## **Feedback on “Stability Phase 3 Connection Approach” Document**

Figure 1: Current evaluation system.

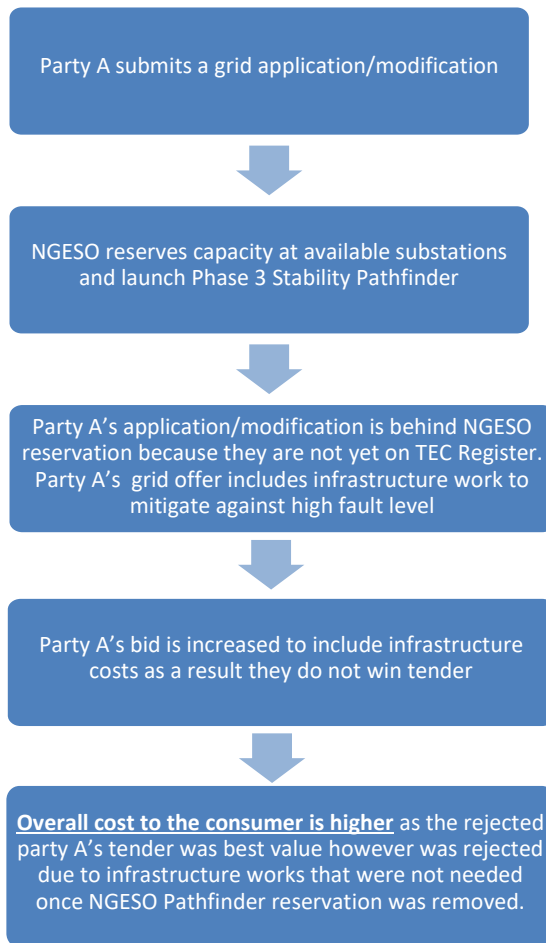
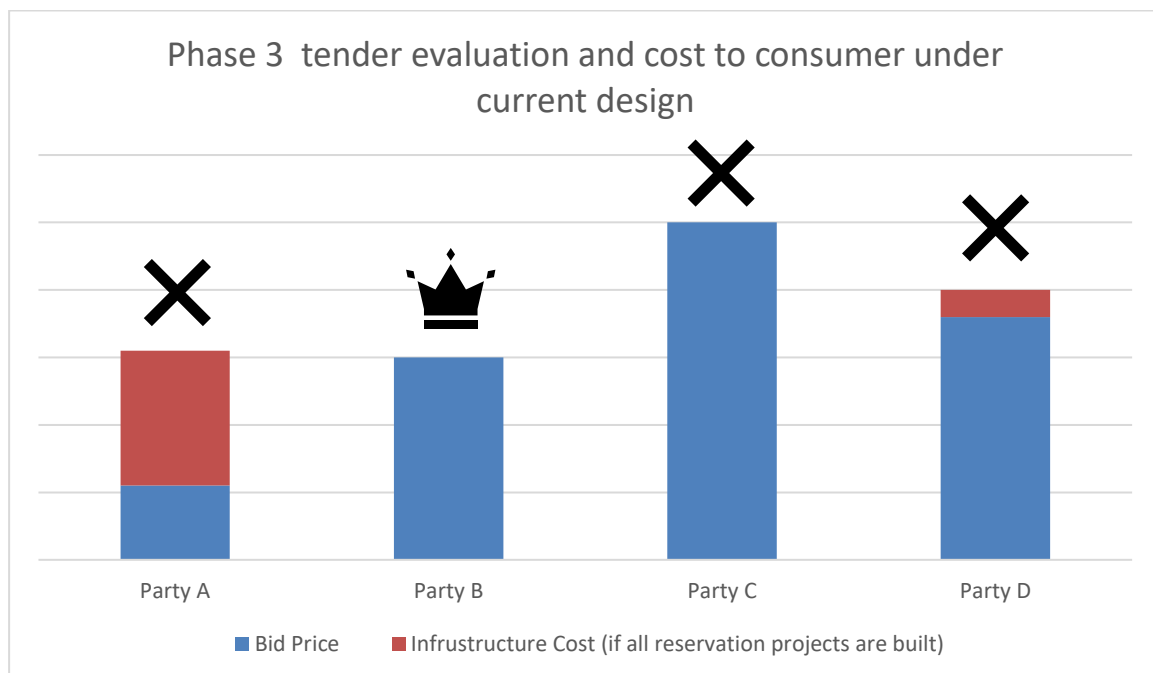
There is however an issue with parties who are connected or may be connected at adjacent or nearby substations. These parties do not benefit from allocated connections and will have to apply for new or modified connections. Their applications can result in the same situation as Pathfinder Phase 2 where cumulative fault level from existing background, Phase 3 allocated bays, and the new party results in predicted high fault levels and switchgear replacement costs. This scenario is shown in Figures 1 and 2.

Figure 3: Proposed change to evaluation process.

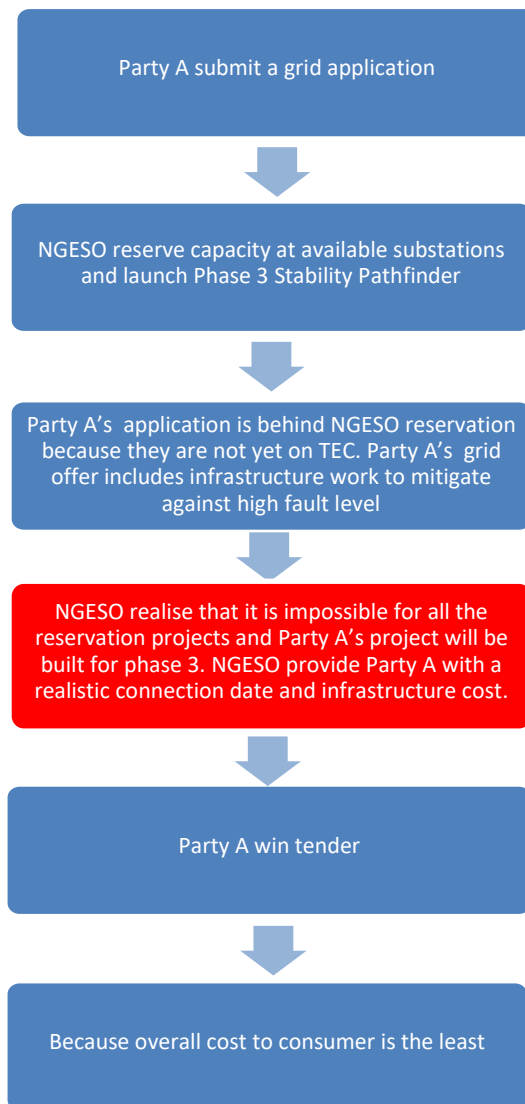
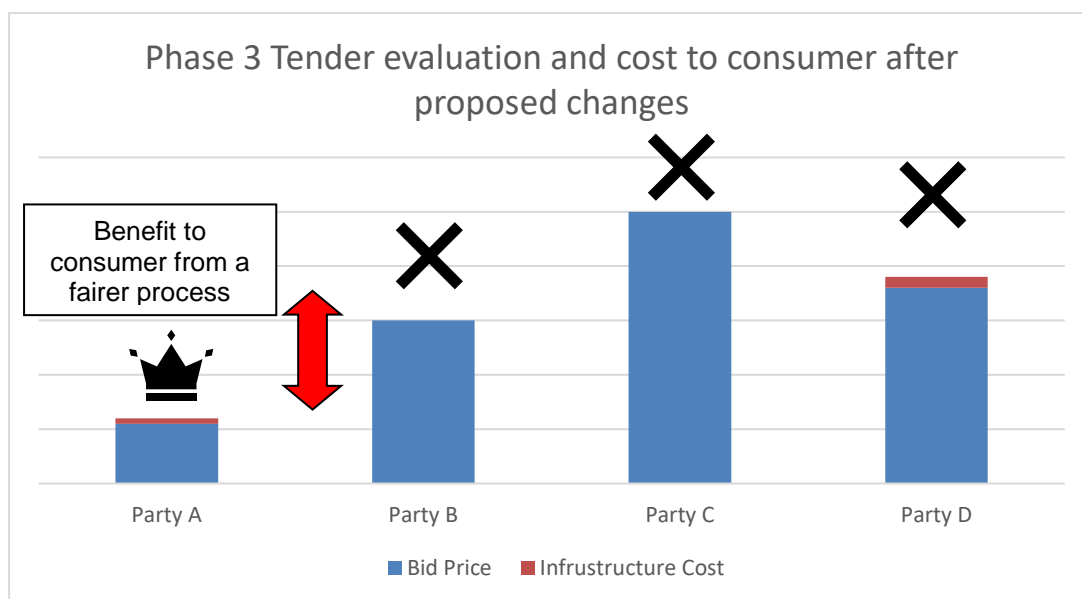
Without changes to the Connection Approach this system could result in a much higher cost outcome to the consumer. Hence the proposal below to improve the Connections Approach in order to remove this risk. The proposal would allow the projects at adjacent substations to be given access to the fault level headroom if this is the lowest cost solution in the tender. Infrastructure costs should be fully investigated on a site by site basis allowing solutions at adjacent substations to access reserved fault level headroom as proposed by Figure 3 and 4.
